**Cambridge  
Crossing**

| Parcel H

OFFICE BUILDING - DESIGN REVIEW REVISION

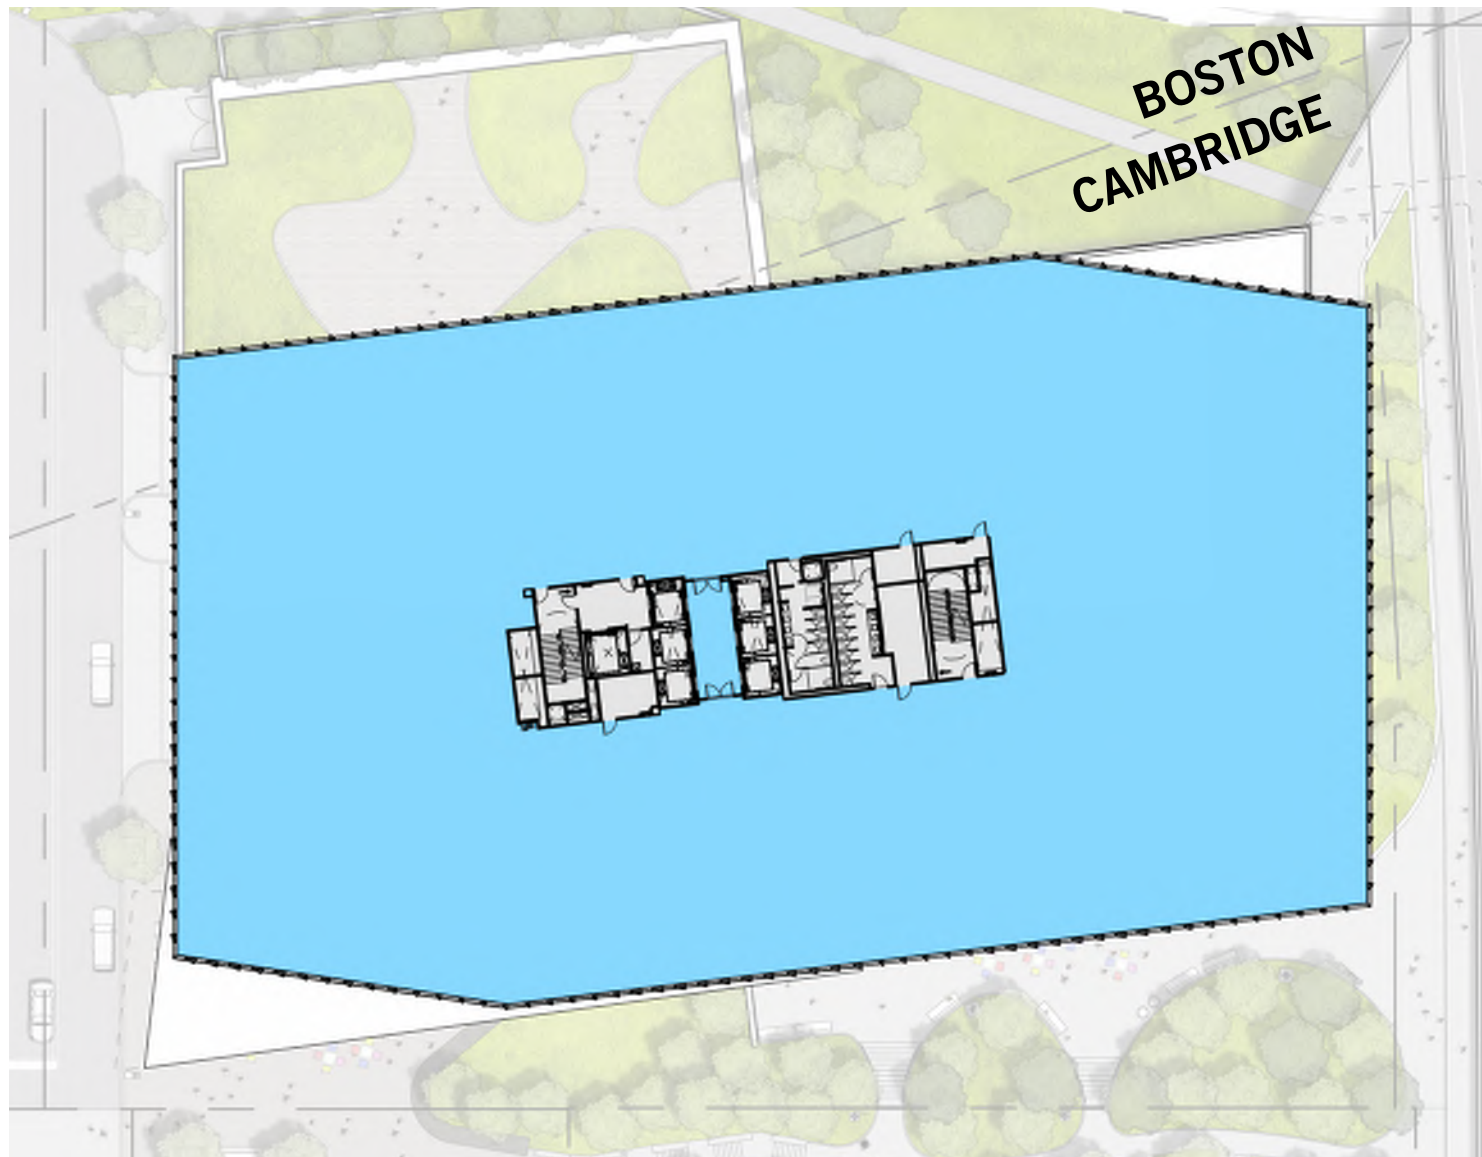
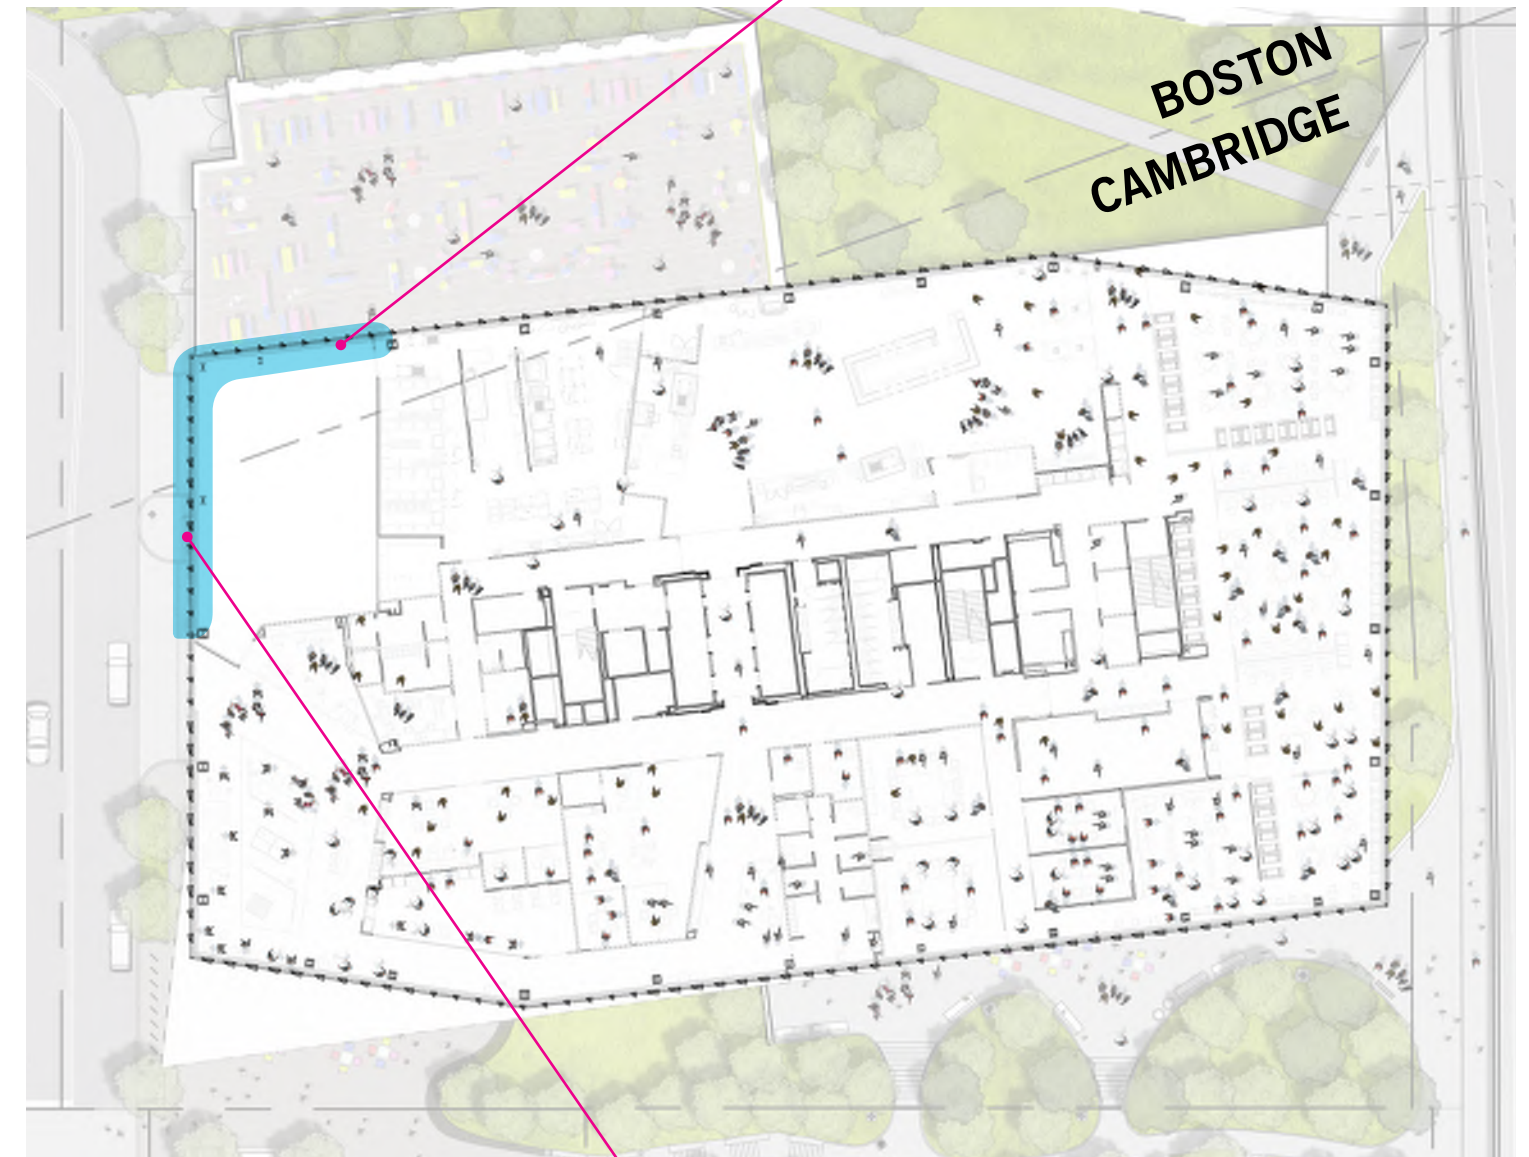
### DESIGN REVIEW REVISIONS LIMITED TO:

- Added Louvers on West, Not on Primary Facade
- Extended Approved Shadowbox Detail at New Mechanical Room

ADDED LOUVERS ON WEST FACADE

EXTENDED APPROVED SHADOWBOX  
DETAIL AT NEW MECHANICAL ROOM

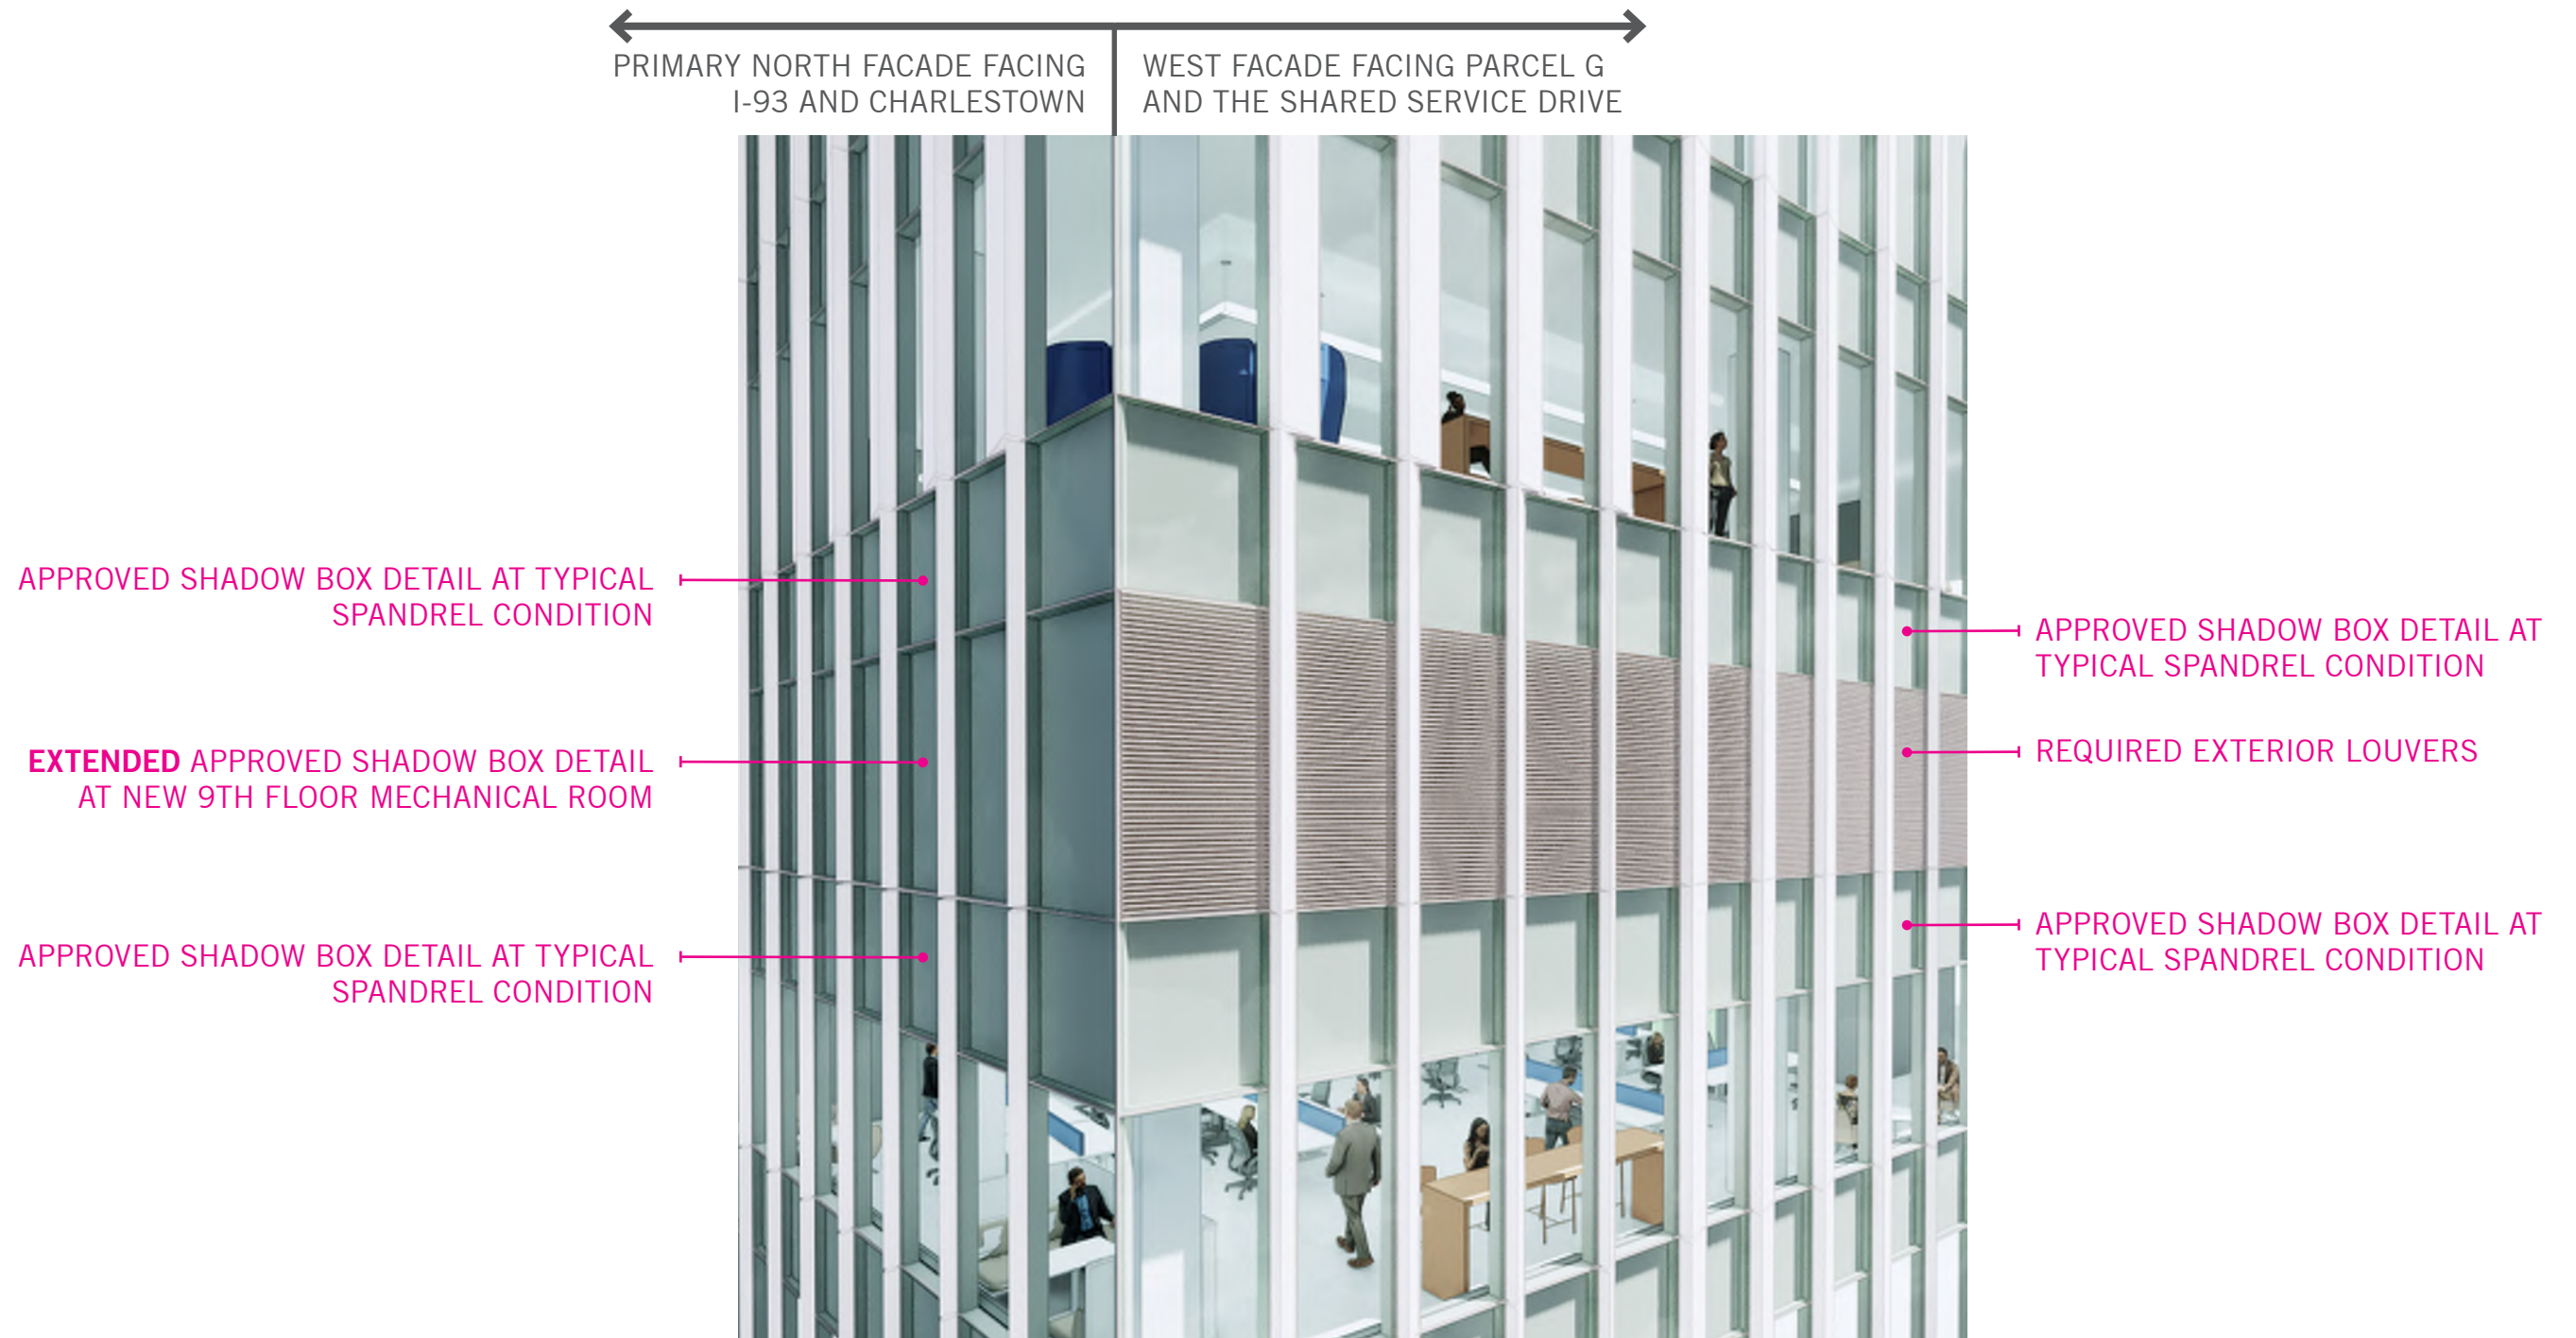
### DESIGN REVIEW REVISIONS LIMITED TO:

- Added Louvers on West, Not on Primary Facade
- Extended Approved Shadowbox Detail at New Mechanical Room
